MEMORANDUM

SUBJECT: Pease Park, License Agreement
Phillip Bobitt - Driveway

Espey, Huston and Associates, on behalf of Phillip Bobitt, have requested approval of a license agreement for a driveway through part of Pease Park.

PROPOSED
DRIVEWAY

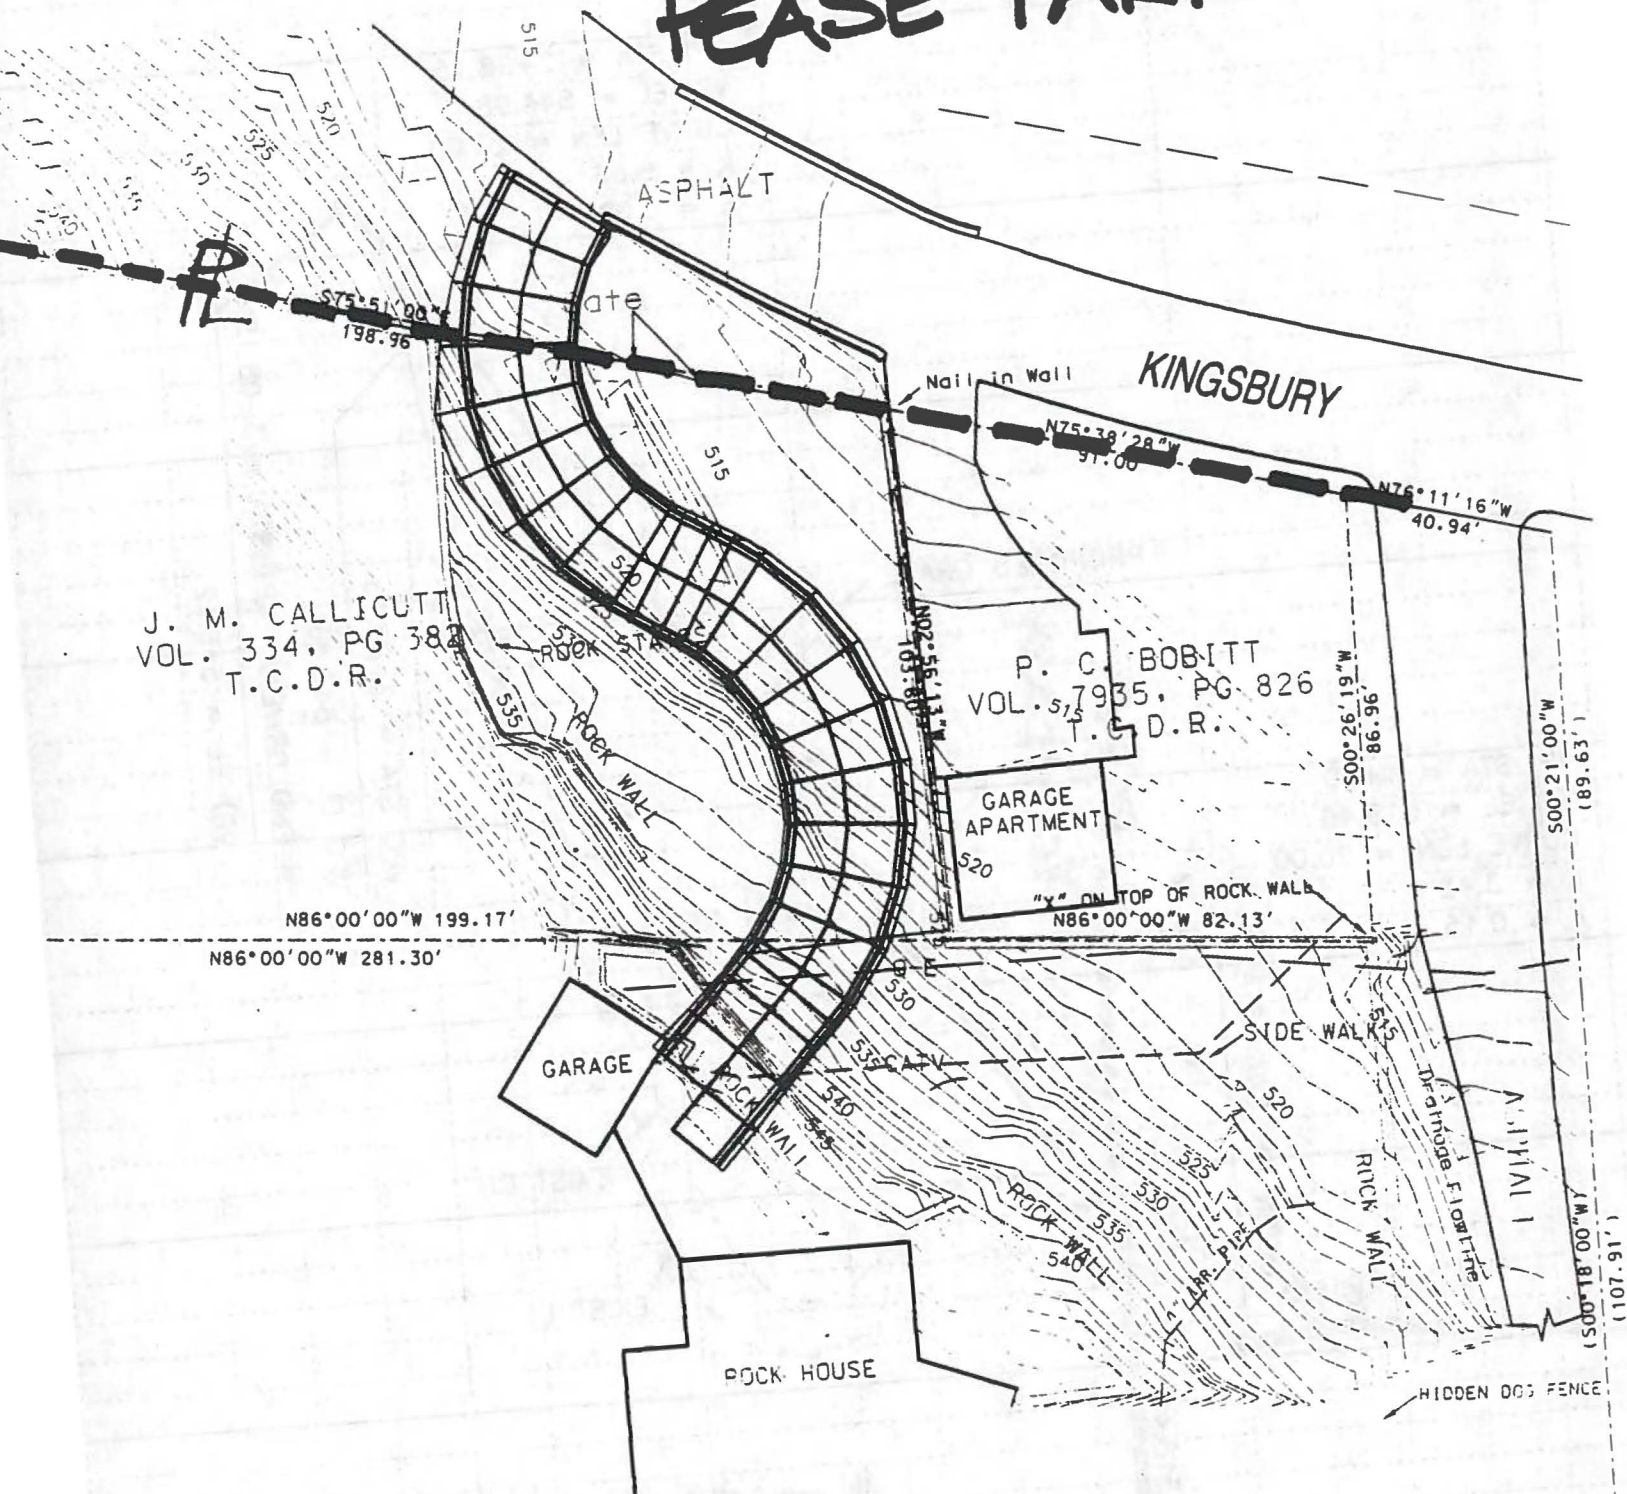
As you will see from the attached drawings, it is proposed to construct the driveway from Kingsbury to the rear of the property that fronts onto Windsor Road. Part of Pease Park is located between Kingsbury and Windsor Road and it is necessary for the driveway to cross parkland.

The driveway is proposed to rise 31' from an elevation of 515' at Kingsbury to 546' at the rear of the property. Espey, Huston, the consulting engineers, have calculated this to be a grade of 15.86% or approximately a slope of 1:6. Because of this steep grade, the driveway at the property line of the park would need to be cut on the uphill side and filled on the downhill side.

CROSS SECTION AT
PARK BOUNDARY

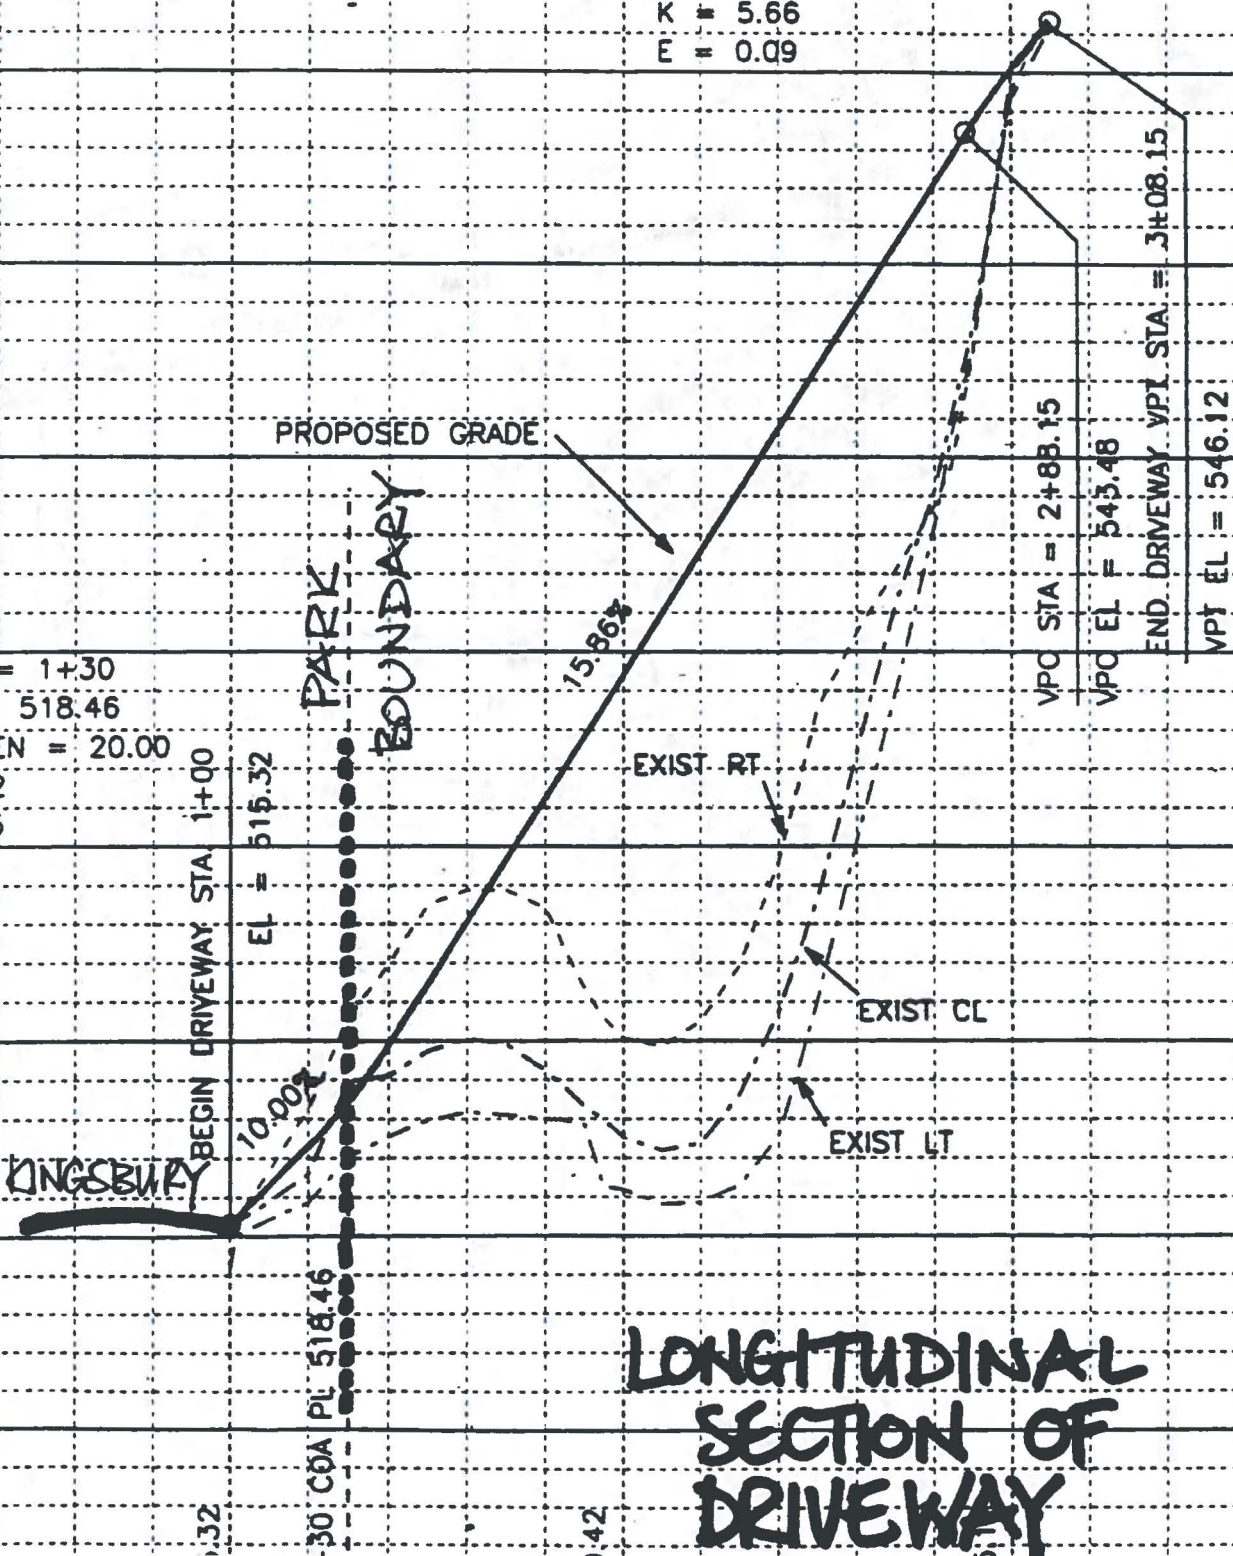
With 2:1 side slopes, the uphill side would be cut back to a height of approximately 10', and the downhill side filled to a depth of 2 1/2'. This construction would require a cleared width through the parkland of approximately 50'. If retaining walls were used, the disturbed width would be reduced to about 32' with vertical walls approximately 3' high on both up and downhill sides.

The second consideration, does the project include all reasonable planning to minimize harm to the park? The steep grade of the drive requires that substantial excavation and fill to elevate the road through parkland, which creates a cleared swath at least 30' wide through a natural vegetated buffer. I do not feel that this project minimizes harm to the park.
